## PRODUCT INFORMATION SHEET - CYLINDER HEAD GASKETS

UE31004P - UT12890PD - 07V103147

This document aims to explain the history of the development of the cylinder head gasket, the issues experienced and the options we can currently offer – 07V103147 and UE31004P.

Fig 3 New Gasket Now Used on ALL Engines (UE 45215)

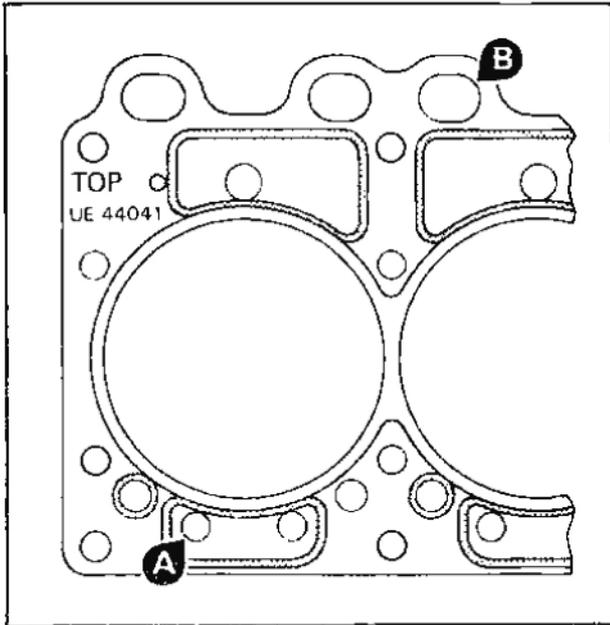
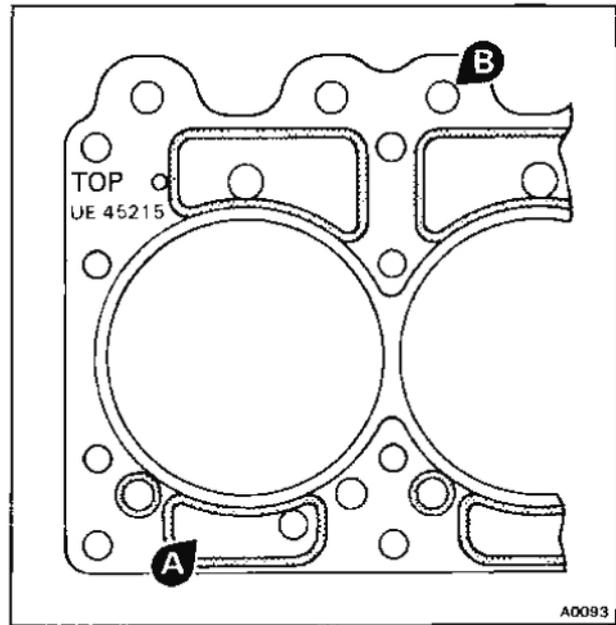
The new cylinder head gasket is similar to that used previously on the Bentley Mulsanne Turbo engine. However, changes have been made to the push rod hole size and one of the coolant hole passages has been deleted (see figs.1 and 3).

- A Two coolant passage holes
- B Size of push rod hole

- A One hole has been deleted
- B Push rod hole decreased in size

The latest gasket (UE 45215) can be used for ALL Bentley Mulsanne Turbo engines, but MUST NOT be used on normally aspirated engines prior to vehicle identification numbers listed above. UE 31004 must be used on all these earlier engines.

The new gasket (UE 45215) should be assembled dry.
